3GPP TSG_CN#7
ETSI SMG3 Plenary Meeting #7,
Madrid, Spain
13th – 15th March 2000

NP-000033

Agenda item: 5.2.3
Source: TSG_N WG 2
Title: CRs to 3G Work Item CAMEL phase 2

This document contains “6” CRs on **Work Item CAMEL phase 2**, that have been agreed by **TSG_N WG 2**, and are forwarded to **TSG_N Plenary meeting #7** for approval.

Figure 45n: Process gsmSSF (sheet 15)

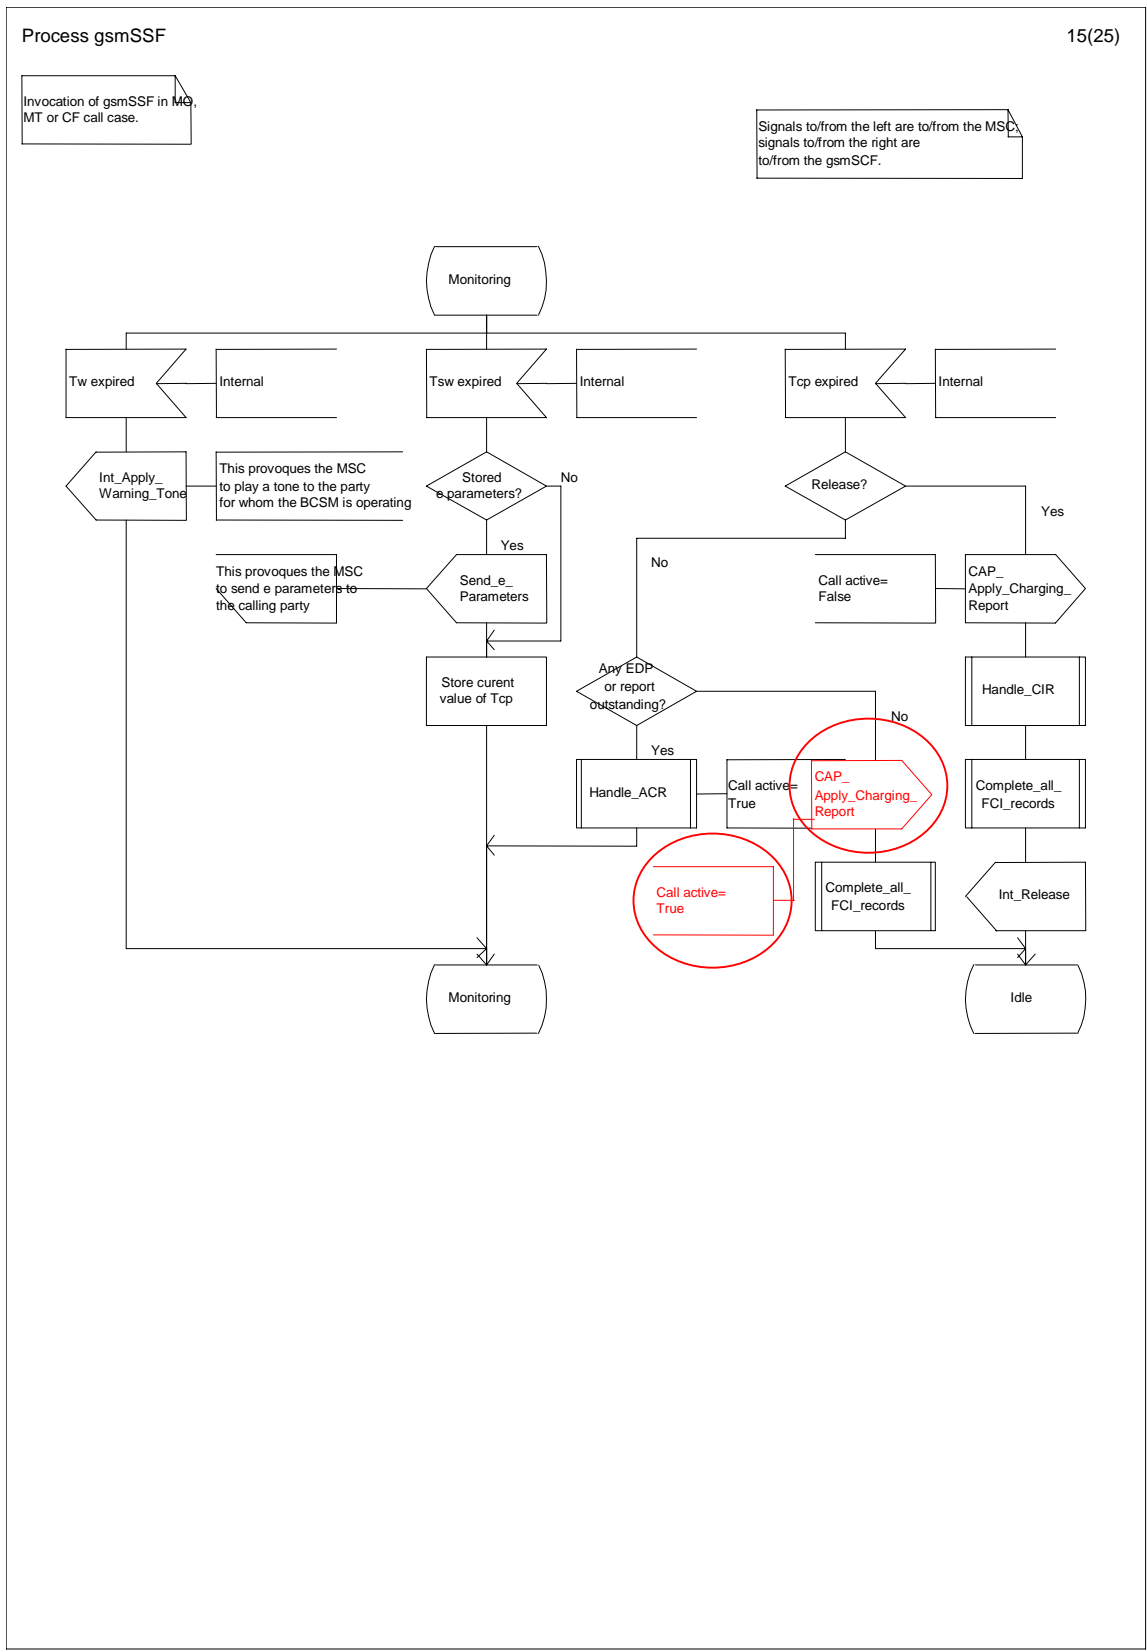
Subject: Correction on gsmSSF SDL; return to idle after ACR

Reason for change: CR 03.78-A105 'Correction on gsmSSF SDL; return to idle after ACR' which was approved at SMG#29 was not correctly implemented. This CR is the correction for the current version.

Figure 4.27a: Procedure CAMEL_MT_GMSC_INIT (sheet 1)

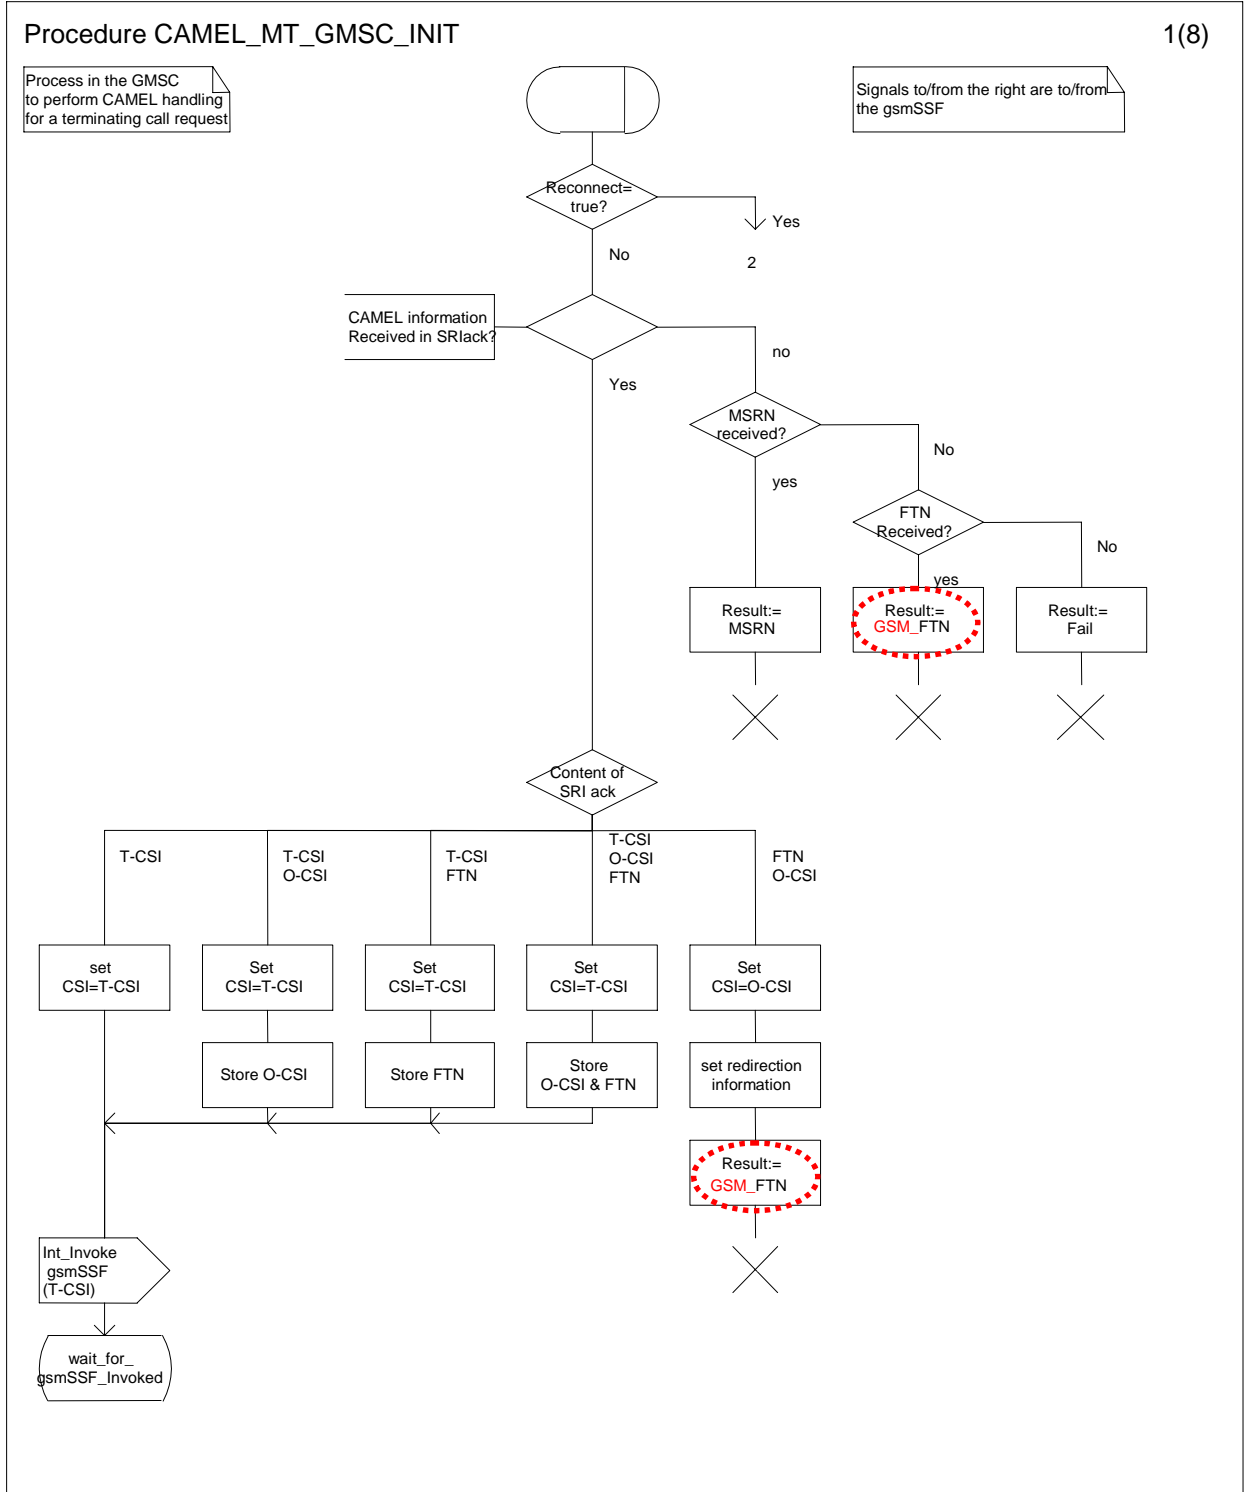
Therefore a new outputs 'CAMEL_FTN' and 'GSM_FTN' are defined in Procedure CAMEL_MT_GMSC_INIT (in GSM TS 03.78). This is to be checked in procedure Obtain_Routing_Address (in GSM TS 03.18). If result = 'CAMEL_FTN' procedure CAMEL_MT_GMSC_Notify_CF (in GSM TS 03.78) shall not be called. CF process shall be started instead.

Figure 4.36: Procedure CAMEL_MT_GMSC_Notify_CF (sheet 1)

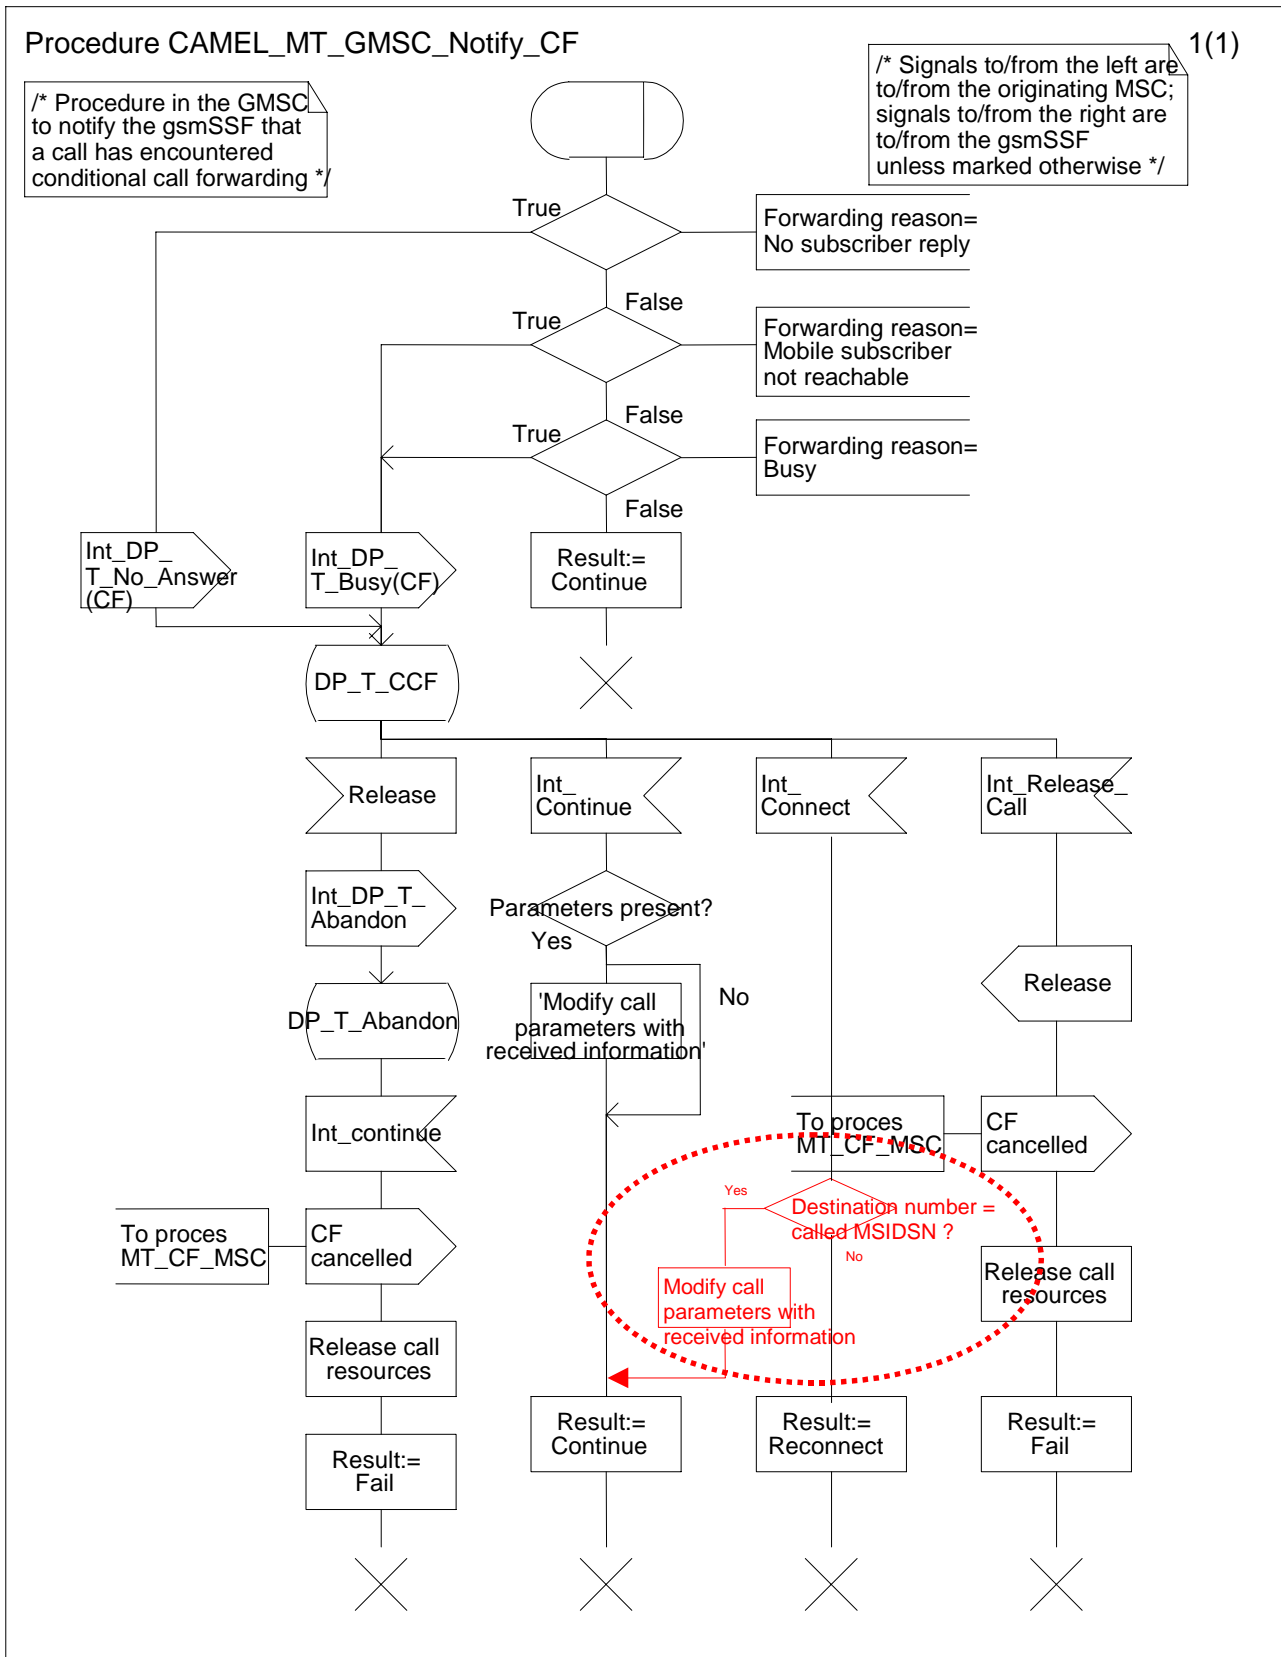
The proposal is to call procedure CAMEL_MT_GMSC_Notify_CF (in GSM TS 03.78) only for GSM-CF, i.e. gsmSCF shall not be notified about new Called Party Number being received from it in CONNECT.

Further, a new check on Called Party Number is proposed in CAMEL_MT_GMSC_Notify_CF procedure. If the same number is delivered in CONNECT then CF process shall be started immediately, i.e. there shall be no Reconnect attempt.

Figure 4.57q: Process gsmSSF (sheet 17)

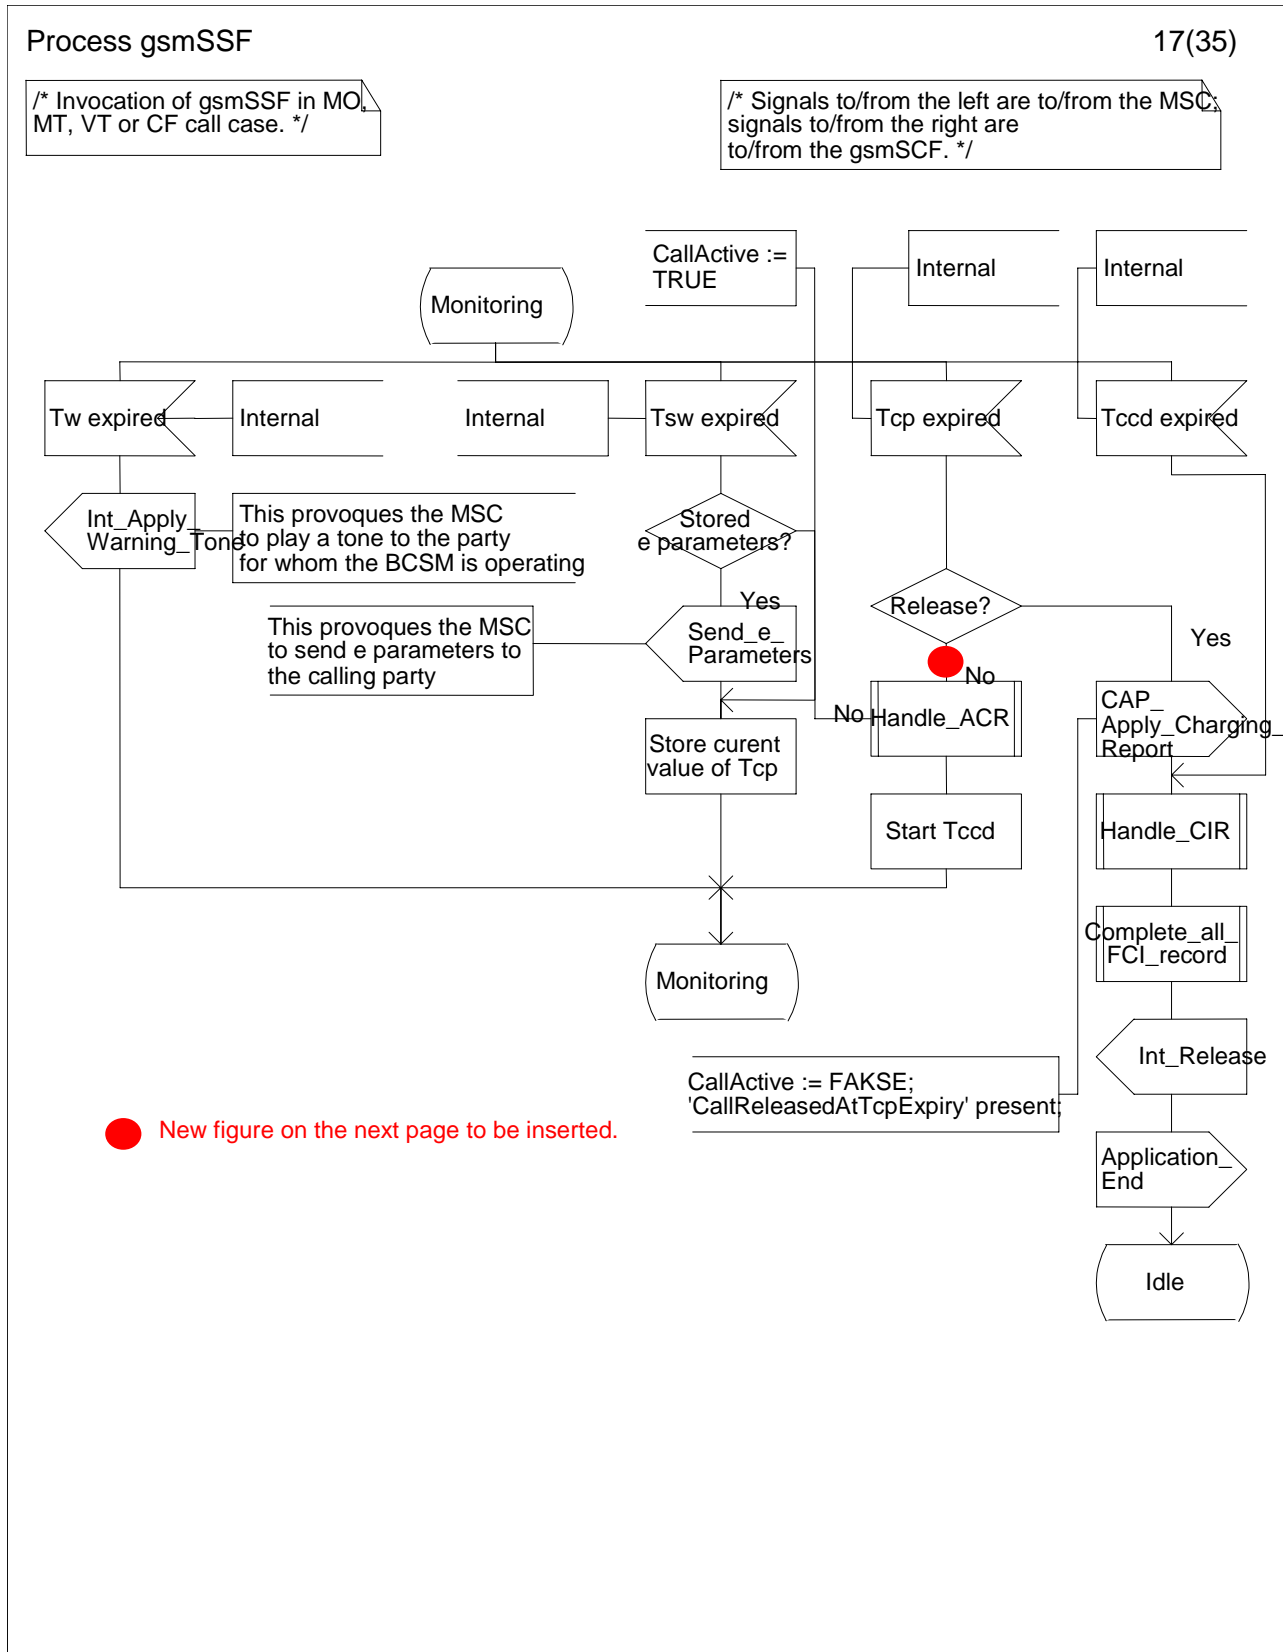
Subject: Correction on gsmSSF SDL; return to idle after ACR

CR 03.78-A105 'Correction on gsmSSF SDL; return to idle after ACR' which was approved at SMG#29 was not correctly implemented. This CR is the correction for the current version.
